Appendix A: Request for Variance

Infrastructure Standards for Telecommunications Spaces v4.0

Request Date:	9/12/2024
Government POC:	Tim Stark
Org Represented:	Castle Point VA Medical Center
Email Address:	Timothy.Stark@va.gov
Contact Phone:	914-776-4654
Site, Building #, Room, Mission of the Facility Where Requested (also note admin vs medical specific use):	Castle Point VA Medical Center Building 35 (Boiler Plant) - 104
Variance Requested:	Per Design Alert 7, the A/E is requesting use of a non-standard (environmentally conditioned) TE

Drawing Title: BUILDING 35 - LEVEL 01 - FLOOR PLAN	Phase: 95% DESIGN DEVELOPMENT	Project Title: EHRM INFRASTRUCTURE UPGRADES - CASTLE POINT	Project Number: 620A4-22-700
			Building Number: 35
Approved:	FULLY SPRINKLERED	Location: VA HUDSON VALLEY MEDICAL CENTER, 41 CASTLE POINT ROAD WAPPINGERS FALLS, NY 12590	Drawing Number: 35A-401
		Issue Date: 09/13/2024 · Checked: JG/MA · Drawn: JG/SGS

1 LEVEL 01 - FLOOR PLAN

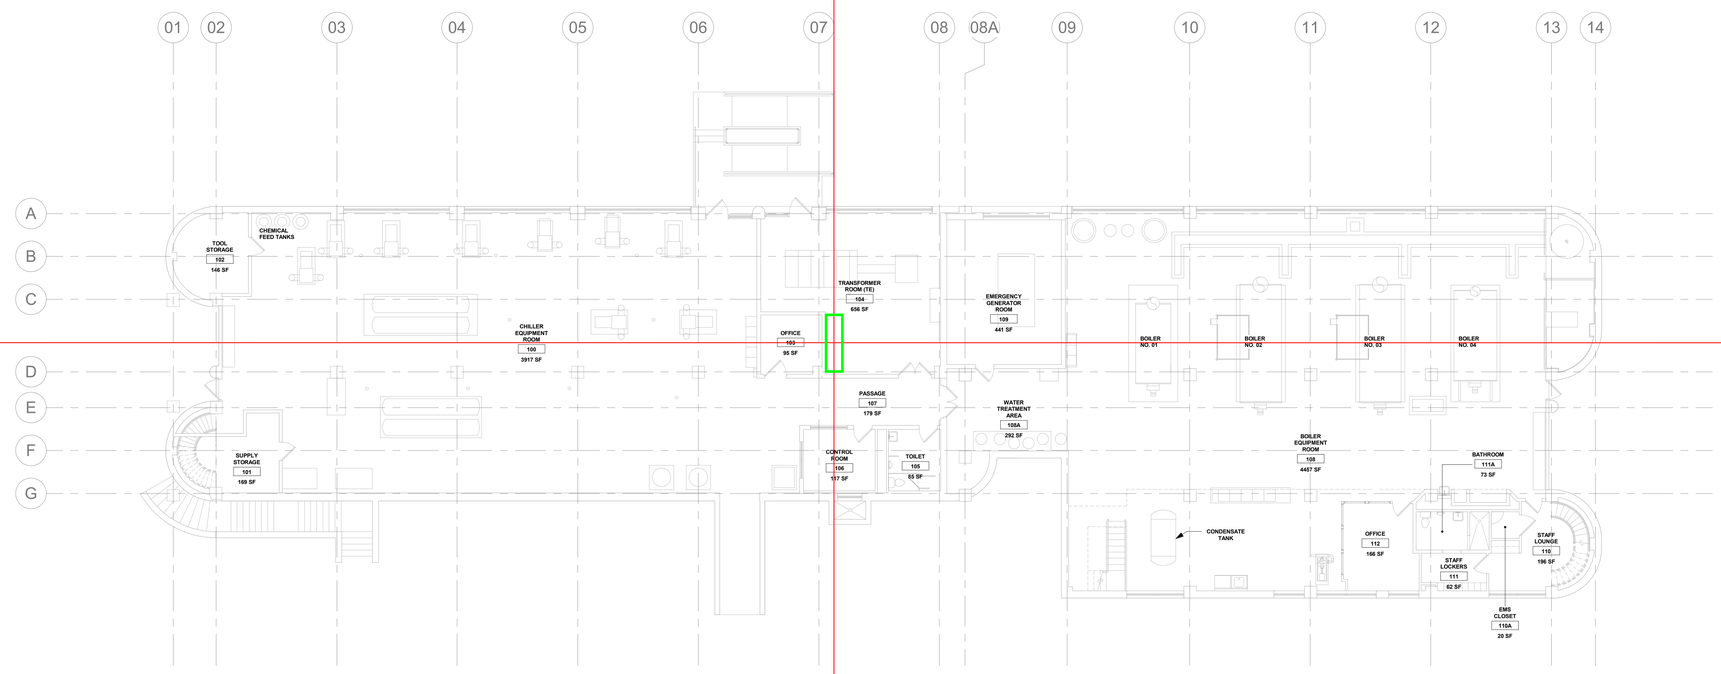
1. VA APPROVED TE 104A.
2. TE TO BE ADDED TO EXISTING SPACE IN TRANSFORMER ROOM.
3. TE IS SHARING SPACE WITH A ROOM WITH ANOTHER PURPOSE, AS PER DESIGN ALERT 9 IS NOT ALLOWED. HEFP DOES NOT CONSIDER THIS ROOM TO FALL INTO A CATEGORY OF AN AREA READILY TO GENERAL FOOT TRAFFIC.
